Appendix J.3

Comment Letters

Subject: Draft Environmental Assessment for the proposed Oberon Solar Project, Riverside County, California

Subject: Draft Environmental Assessment and Land Use Plan Amendment for the Oberon Renewable Energy Project (DOI-BLM-CA-D060-2020-0040-EA), Riverside County, California

Figure 1. BLM-designated multi-species wildlife linkages (shown in red) in DRECP LUPA/FEIS.

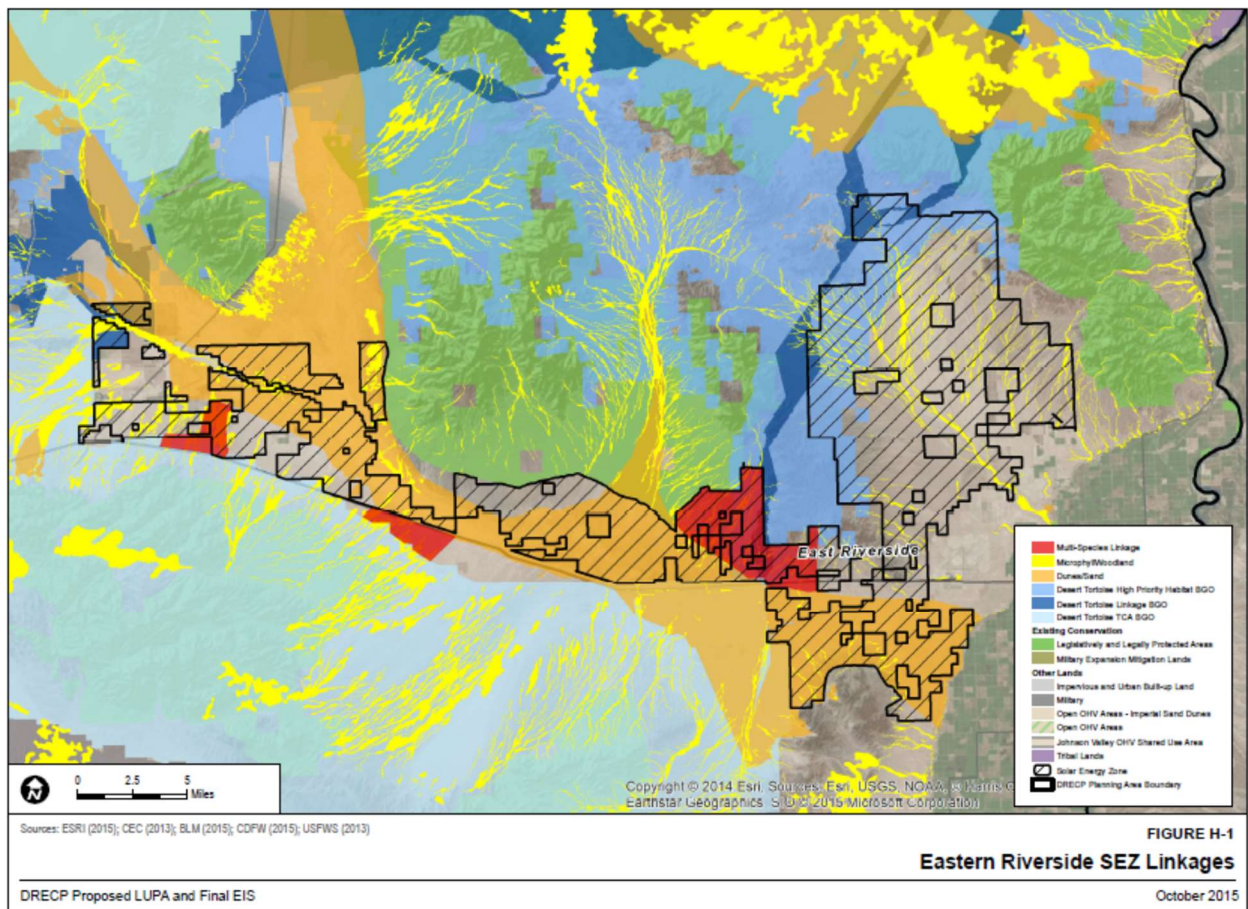
The Oberon EA fails to adequately analyze and mitigate impacts to the multi-species wildlife linkage and connectivity. Wildlife connectivity corridors and linkages are place-based areas that are often unmitigable if impacts occur in them (Spencer et al. 2010). The DRECP identified and established three wildlife connectivity corridors/linkages, two of them within the boundaries of the Riverside-East DFA (See Figure 1, taken from DRECP LUPA/FEIS, Appendix H-1).

Oberon is located partially within the most westerly wildlife connectivity corridor. Figure 1 shows the overlap of the proposed Oberon project's solar array field into the BLM-designated Wildlife Connectivity Corridor. The EA fails to identify the impact to the multi-species linkage from the proposed project. Based on GIS layers from the DRECP, the fenced solar arrays cover 325 acres of the multi-species linkage. In addition, it fragments the linkage, making the linkage less functional for wildlife to move unimpeded through it (Ibid). We recommend that the EA be revised to fully analyze impacts to the multi-species linkage and comply with the DRECP.

Figure 2. Proposed Oberon Project's overlap with BLM-designated Multi-species Linkage in the Riverside-East DFA.

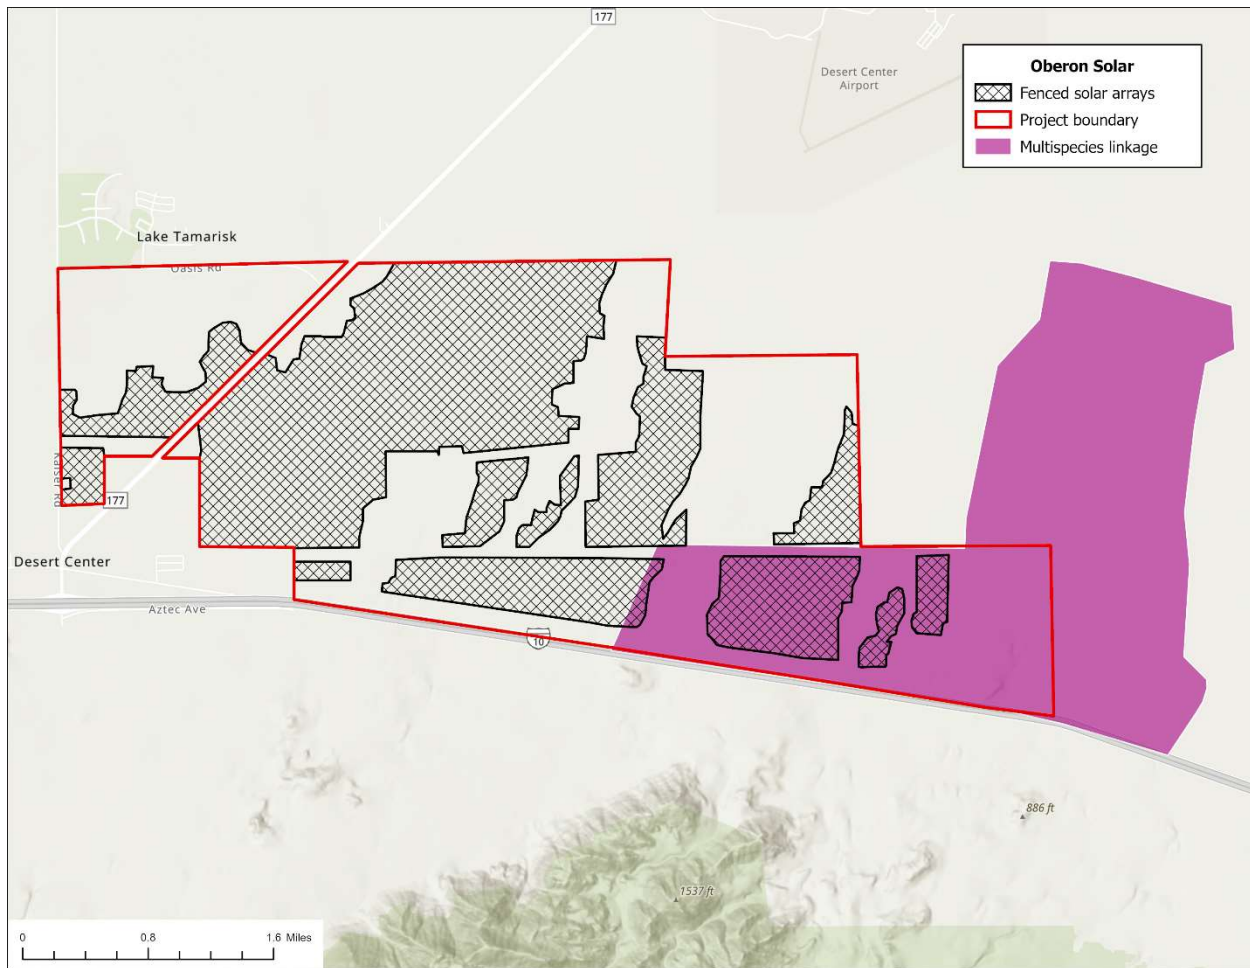
Figure 2.2 in Appendix B of the Oberon EA is troubling because it reveals the potential extent of cumulative impacts from other existing and proposed renewable energy projects in the western Chuckwalla Valley. One of those is the Easley Project, proposed by Intersect Power, which is also the proponent of Oberon. The Easley Project is located just to the north of the Athos and Victory Pass projects. Victory Pass would impact the multi-species linkage by placing solar arrays within the linkage. The Athos project, which is not on BLM-managed land and is currently under construction, has already constricted over half of the northern part of the linkage on the west. The proposed Easley project's southern or northern areas have the potential to block the northern part of the linkage, thereby completely eliminating the functionality of the multi-species linkage. BLM must comply with the DRECP and maintain the wildlife linkages and analyze all the known direct, indirect and cumulative impacts to the multi-species wildlife linkage.
